MEMORANDUM

Date: August 3, 2023
To: Mr. Alan Rappleyea, Multnomah County Hearings Officer
From: Dana Beckwith, PE, PTOE
Re: **Response to Select Testimony from Land Use Review Process
for the Filtration Facility and Pipelines**

P18-035

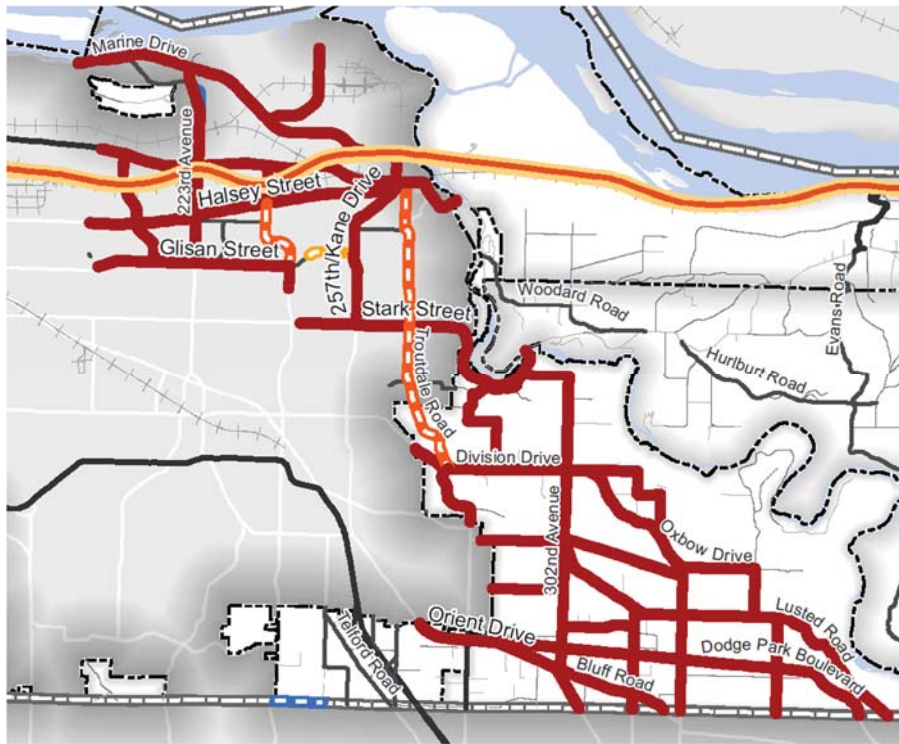
The H.8 traffic engineer indicates that some impacted roadways were neither designed nor constructed with the intention to support high volumes of truck traffic.

Response to Comment: This is an incorrect assumption on roadway construction. Traffic volumes along project area roadways are well below the volumes these roadways are designed to support. Rural collectors are designed to carry between 1,000 and 4,000 Average Daily Trips (ADT) per the County's **Functional Classification of Trafficways Findings and Recommendations Technical Report, Appendices A and E**. This document defines rural collectors as follows:

Rural Collector Roads - Rural collector roads are well connected in rural communities to distribute automobile traffic over large areas and generally connect to urban streets or rural arterials. Where rural collector streets connect roads in adjacent counties, through traffic will occur with volumes greater than local rural roads. They may also provide recreational trips by auto, bicycle and equestrian. Primary access is provided to land uses adjacent to the facility and over large rural districts. **Rural collector roads provide for necessary truck transport of (agricultural, timber and minerals) out of rural districts.** [Emphasis added]

Collectors within the project area are typically currently operating under a 1,500 vehicle ADT except for Bluff Road with a 2,700 ADT and Hosner Road with a 2,100 ADT. The addition of construction traffic will not cause these roads to exceed 4,000 ADT. Therefore, the collector roadways to be used by the project are designed and constructed to handle sufficient capacity for the project and for project construction.

Table 2.2.5 Rural Cross Sections

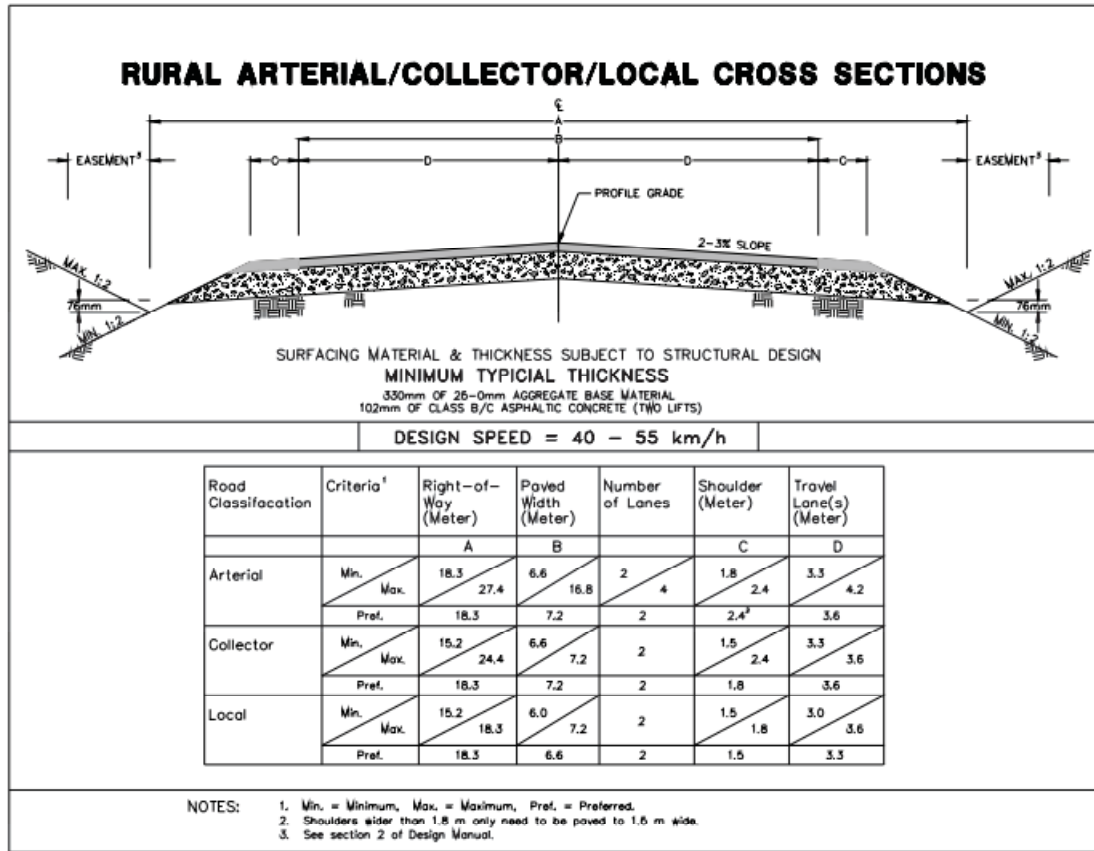
Dedicated facilities will be needed to accommodate people walking and biking on Carpenter Ln to address increased traffic loads.

Response to Comment: The applicant is widening and reconstructing Carpenter Lane to facilitate traffic volumes during construction and during on-going operations. The applicant is required to develop the roadway improvements to meet Multnomah County Design Standards. Pavement design and lane widths will meet the County's Rural Collector standards for rural roads. These standards do not specify sidewalks or bike facilities (the rural roadway cross-section from the Multnomah County Design Standards is shown in the following figure).
